SADDLEHORN RANCH - FILING NO. 2

GRADING AND EROSION CONTROL PLANS

EPC STORMWATER REVIEW COMMENTS ARE SHOWN IN ORANGE BOXES WITH BLACK TEXT

PCD Project Number: SF-21-033

SADLEHORN RANCH - FILING NO. 2
GRADING & EROSION CONTROL PLANS

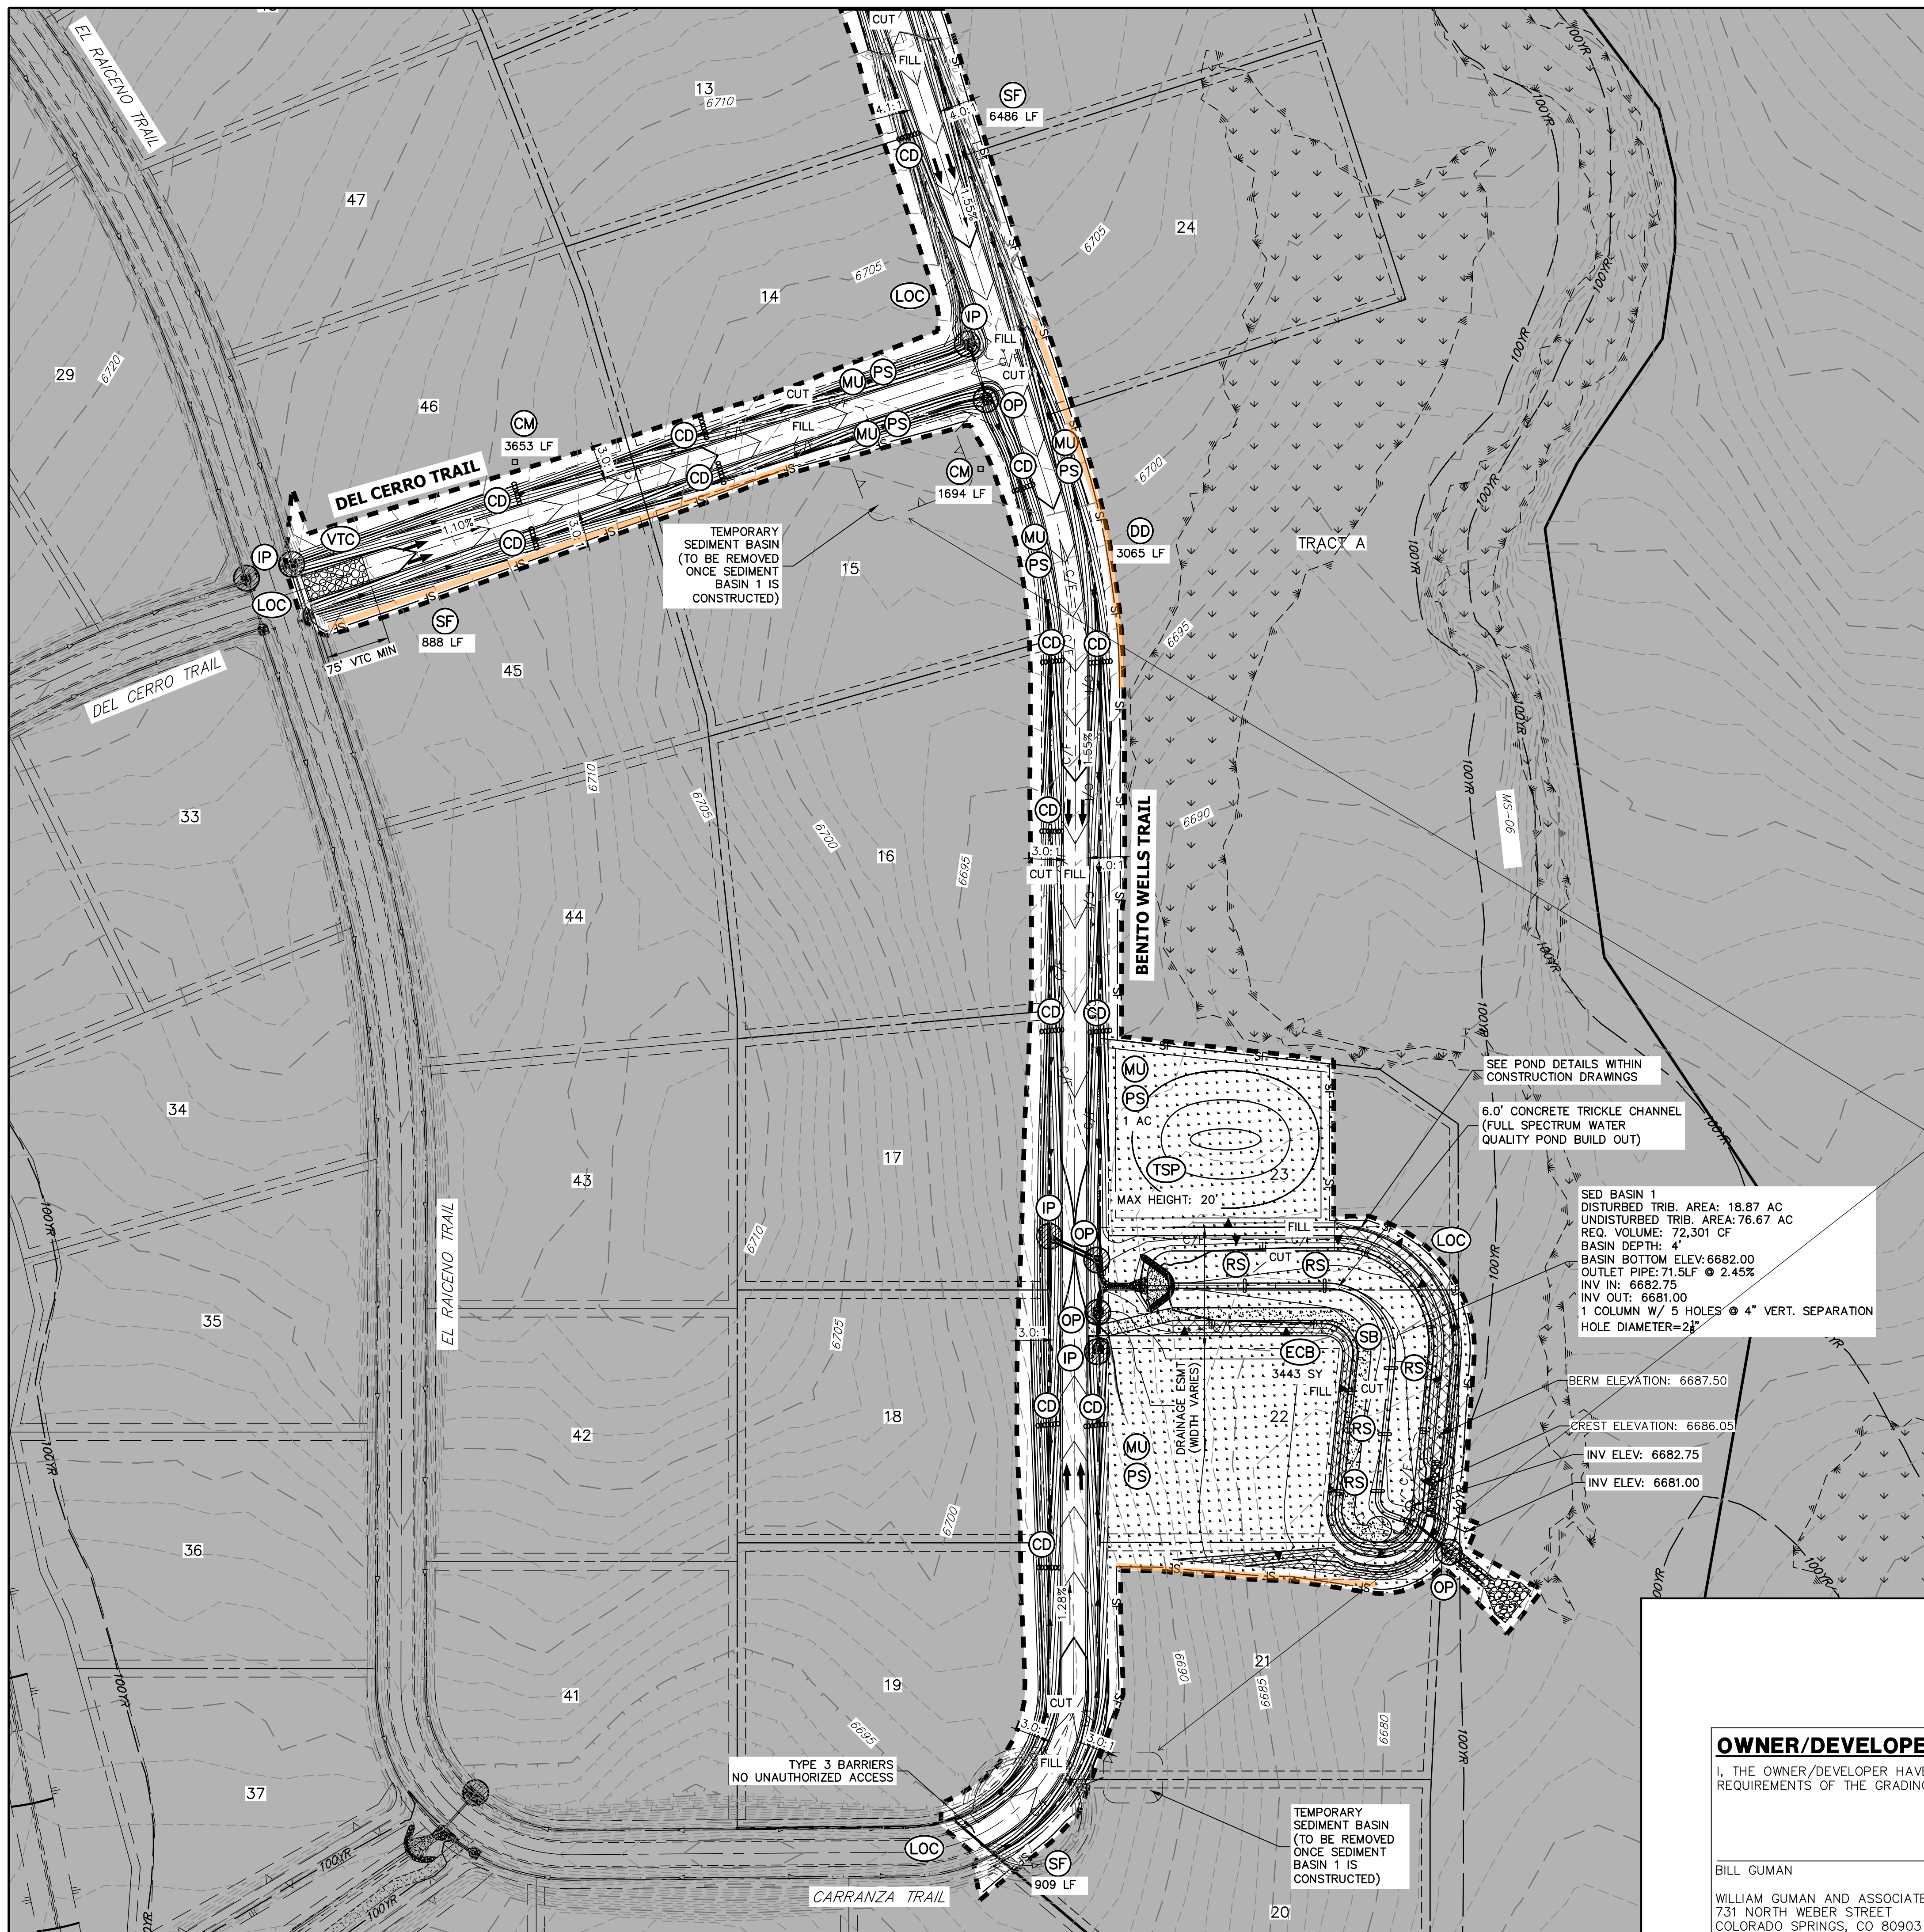
Are these TSBs already existing or will they be installed during the initial phase? If they have not been installed yet, provide details of temporary sediment basin including riser pipe perforation sizing, number of rows, required volume, location of outlet and spillway, and tributary area to the sediment basin. (you can name the two basins and then circle the corresponding details on Tables SB-1 and SB-2 - Sheet 8)
